Q25056-SCH_revK
M17 SIDE SWEEP BOARD

PCB
BOM
Q25056-PCB_revD

DUST 1 VAC CONTROL & CURRENT MONITOR

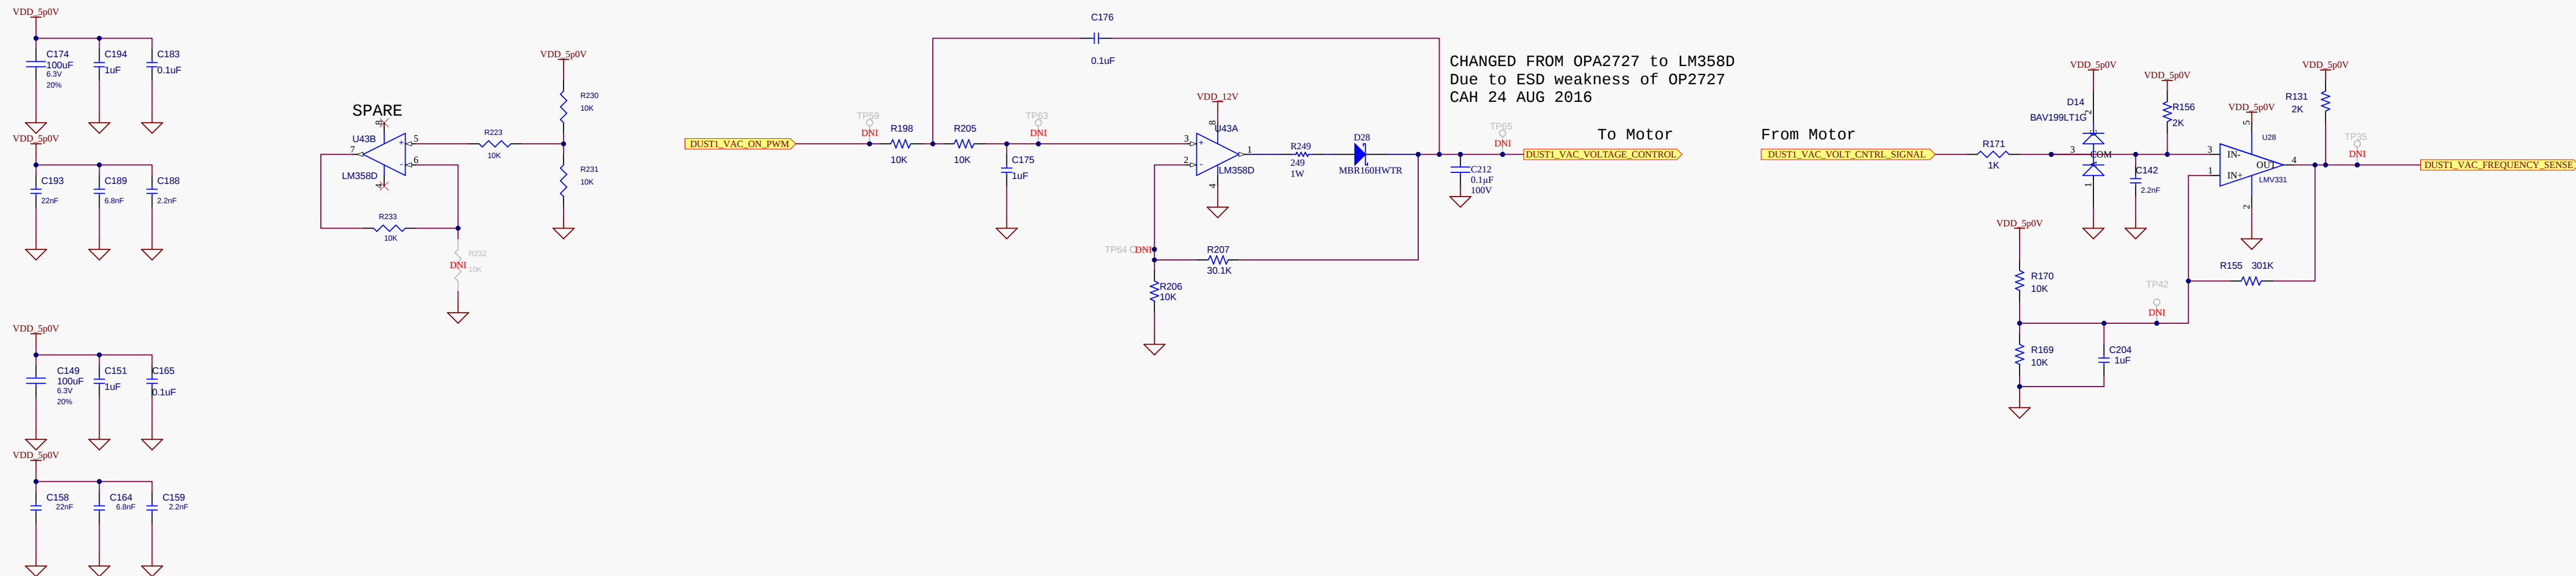
Rev J - Changed Op-Amps for Vac fan circuits from OPA2727 to LM358D.
OPA2727 were having latch-up issues due to ESD coming from FAN.

Rev K - Convert to Altium
Cleaned up excessive text notes, removed notes can be found in changelog in SVN
Change CAN chip to CAN FD part
Add bidirectional TVS diode to PRECHARGE_IN at J4
Add output protections to Dust Vac 1 & 2 and Dry Vac circuits
Changes summary:
+C205, C206, C207, C208, C209, C210, C211, C212, C213, C214
+D25, D26, D28, D29, D30
+R238, R249, R250, R251, R252, R253, R254
-C198, CIN3, CIN4
